то:	CHAIR AND MEMBERS PLANNING AND ENVIRONMENT COMMITTEE
FROM:	GEORGE KOTSIFAS DIRECTOR OF DEVELOPMENT & COMPLIANCE DIVISION AND CHIEF BUILDING OFFICIAL
SUBJECT:	APPLICATION BY: WASTELL DEVELOPMENTS INC. 493 SUNNINGDALE ROAD EAST PUBLIC PARTICIPATION MEETING ON MONDAY MAY 28, 2012 NOT BEFORE 4:15 PM

The purpose and effect of this application is to register a plan of vacant land condominium at 493 Sunningdale Road East, consisting of 38 single detached cluster housing units, with the common element area to include a private stormwater management facility and a private roadway.

FILE NUMBER: 39CD-12504

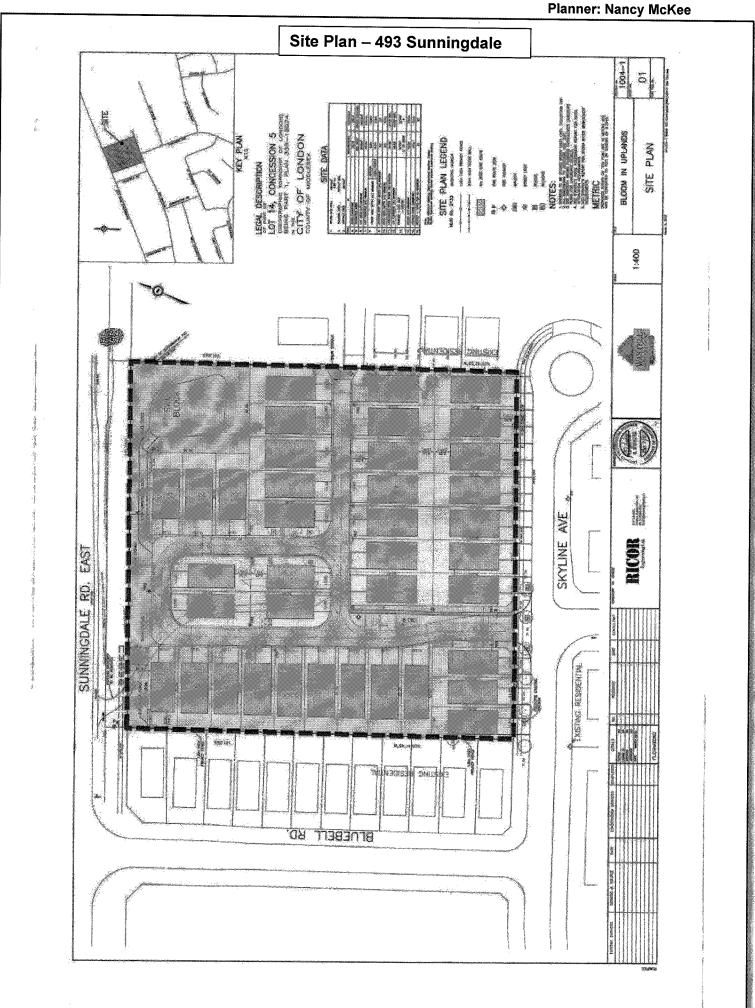
- Special attention should be paid to units facing Sunningdale Road East and those at corners and view termini - recommended wraparound porches be included as prominent design elements.
- Note that units facing Sunningdale Road East should present their "fronts" to the street, not their "sides".
- Some elevations show front facades dominated by garages. Note that front porches are
 to be the prominent design features on front facades, not garages, and the applicant is
 encouraged to explore options that ensure this.

- Units facing Sunningdale Road East and those located at view termini (at corners) are recommended to include design elements such as wraparound porches or other elements that will avoid blank walls facing Sunningdale Road East.
- Some elevations show front facades dominated by garages. The applicant is encouraged to explore options that ensure the front facades are not dominated by garages.
